Agenda
Village of Arlington Heights
Design Commission
Community Room, 3rd Floor

Arlington Heights Village Hall
33 S. Arlington Heights Road
Arlington Heights, IL 60005
June 14, 2016
6:30 PM

- A. DC#16-054 - 2 N. Phelps Ave. - SF/Teardown
- B. DC#16-039 - 503 N. Gibbons Ave. - SF/New
- C. DC#16-065 - 415 N. Gibbons Ave. - SF/New
- D. DC#16-056 - Lexington Towne Subdivision - 909 & 929 W. Campbell St. - SF/New
- E. DC#16-063 - Ivy Hotel - 519 W. Algonquin Rd. - Commercial

FRONT ELEVATION
REAR ELEVATION

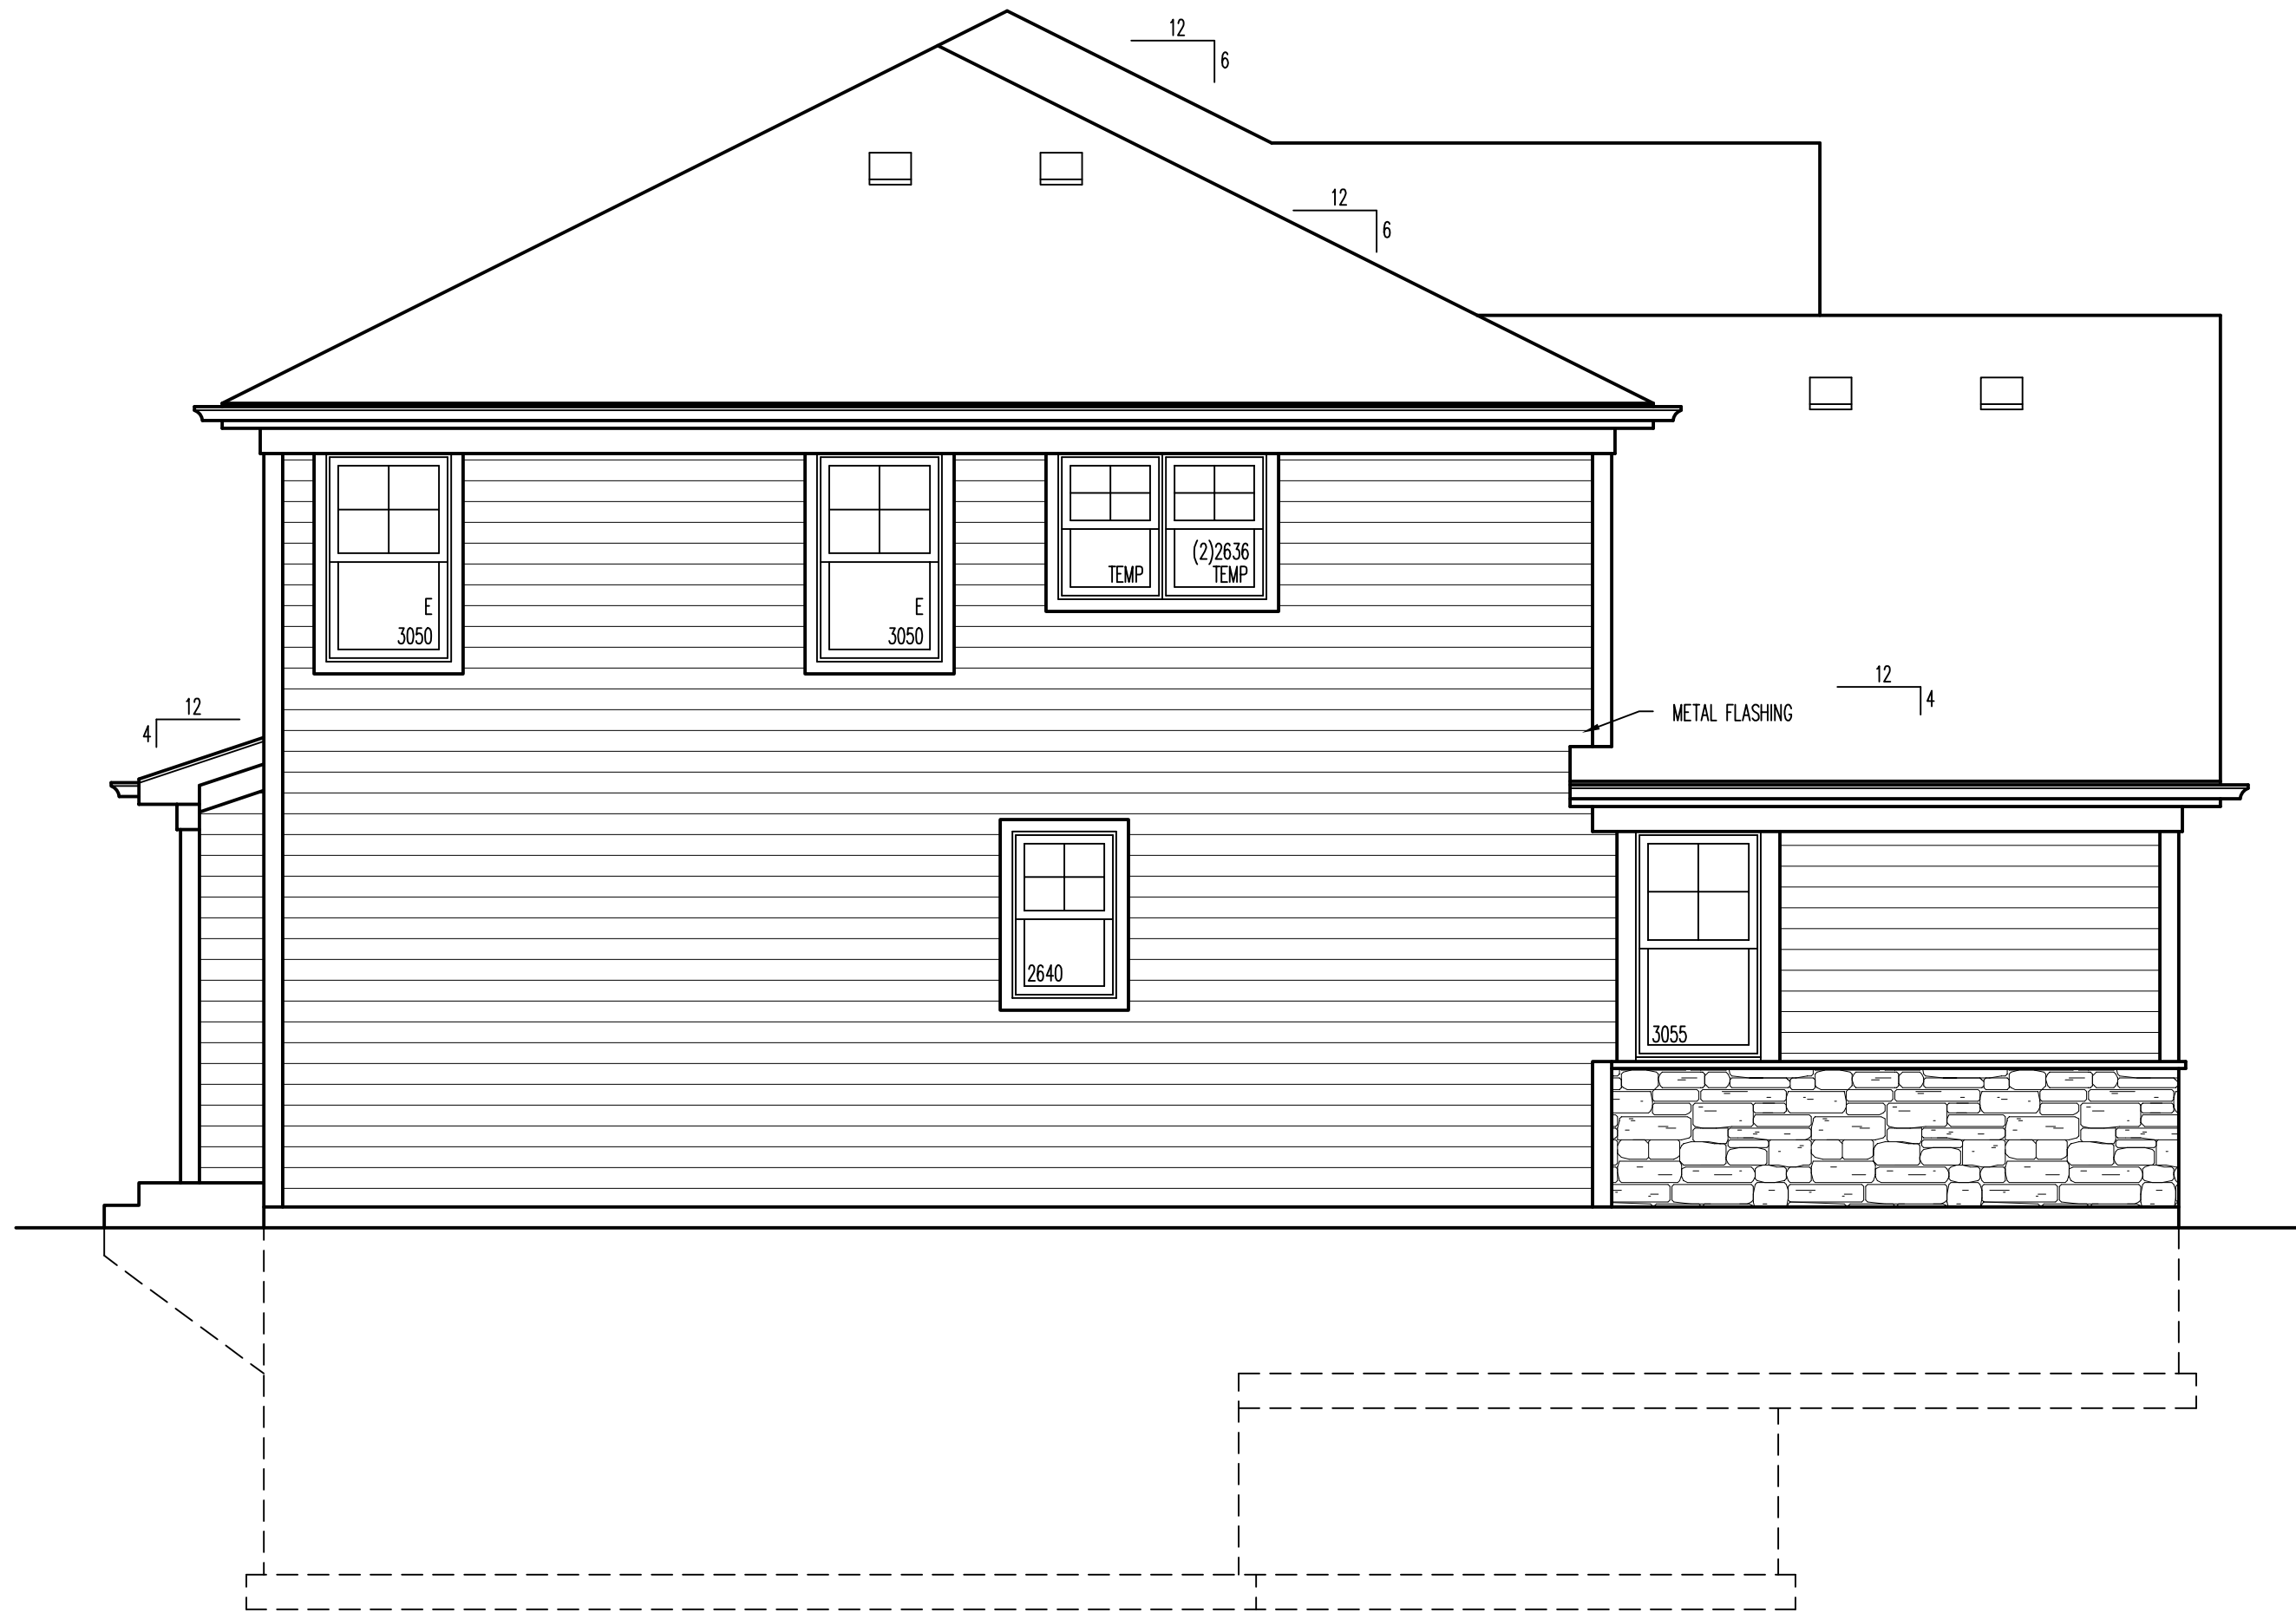
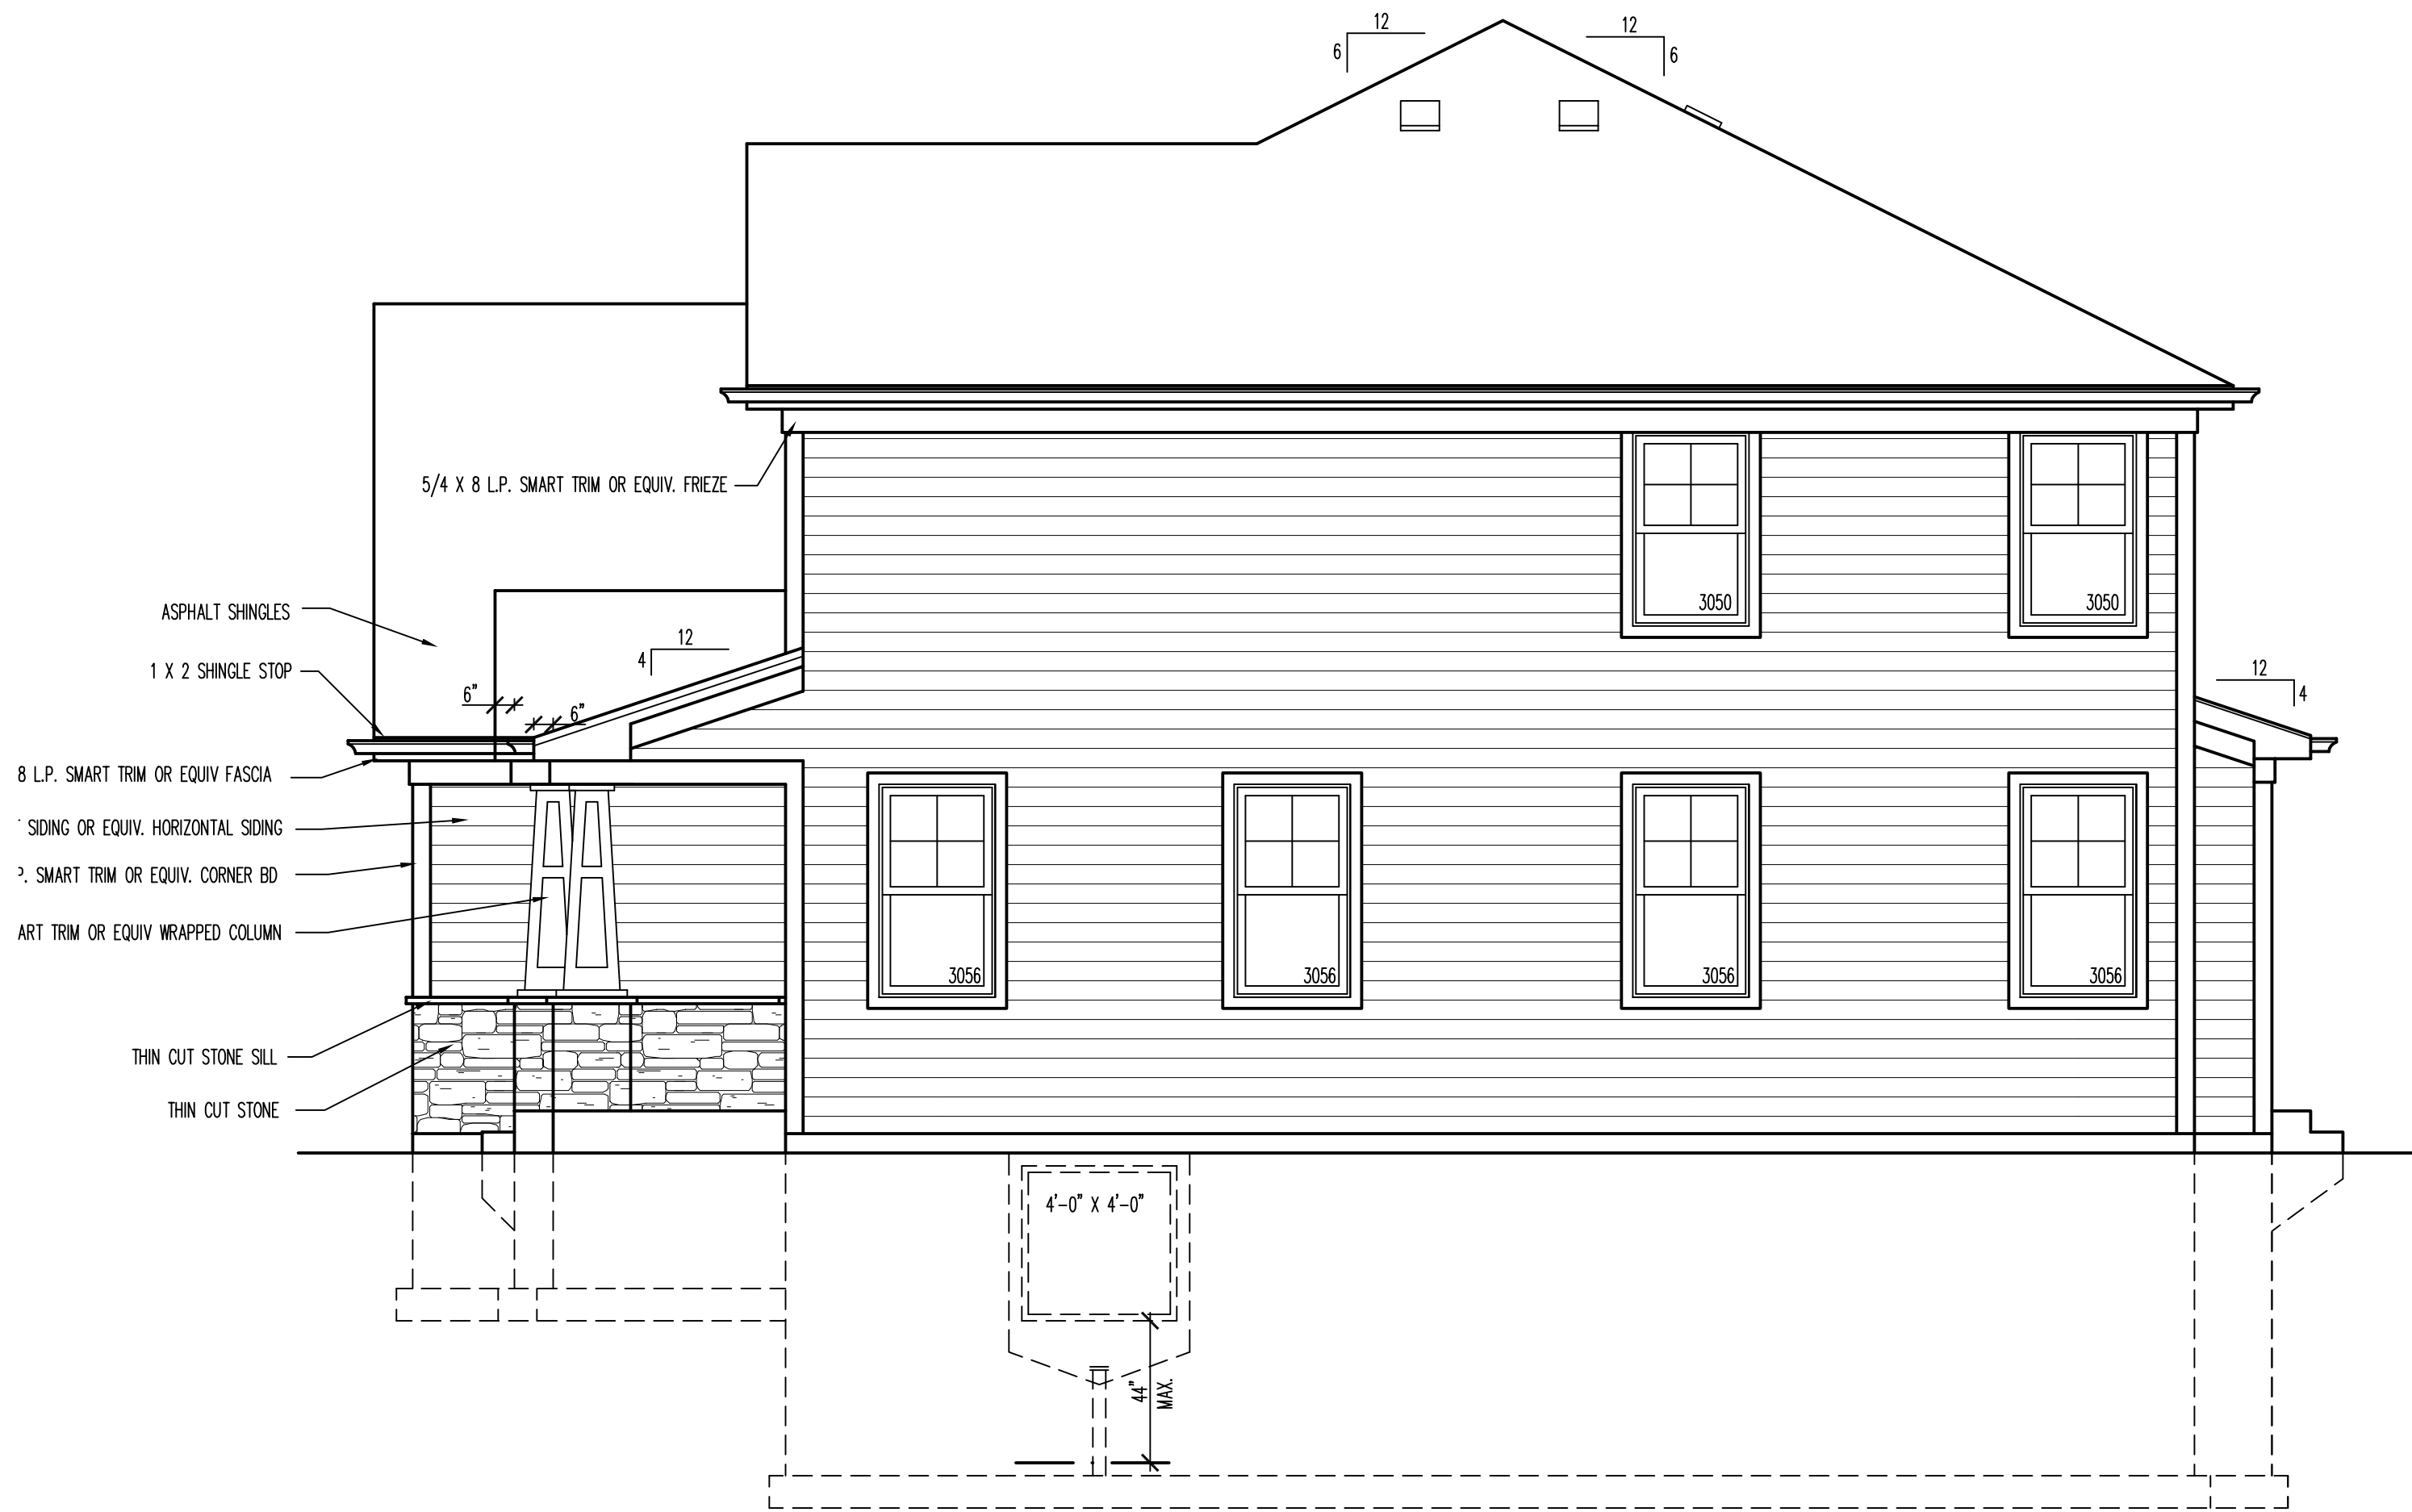
1. All of the homes are proposed to have the same color "Driftwood" asphalt shingles. It is recommended that a different roofing color be provided to create more diversity along the street.
2. The driveway is too close to the existing parkway tree. A minimum of 5 feet of clearance should be provided. Either adjust the driveway layout, or coordinate relocation of the recently planted tree with the Village Forester at the petitioner's expense.

It is recommended that the Design Commission require revisions and approve the proposed new single-family residence to be located at 415 N. Gibbons Avenue. This recommendation is subject to compliance with the architectural plans received 5/26/16, and the following:

1. Provide a different color roofing, to be approved by Staff.
2. Either adjust the driveway layout to maintain a minimum 5 feet of clearance from the existing parkway tree, or coordinate the relocation of the recently planted tree with the Village Forester at the petitioner's expense.
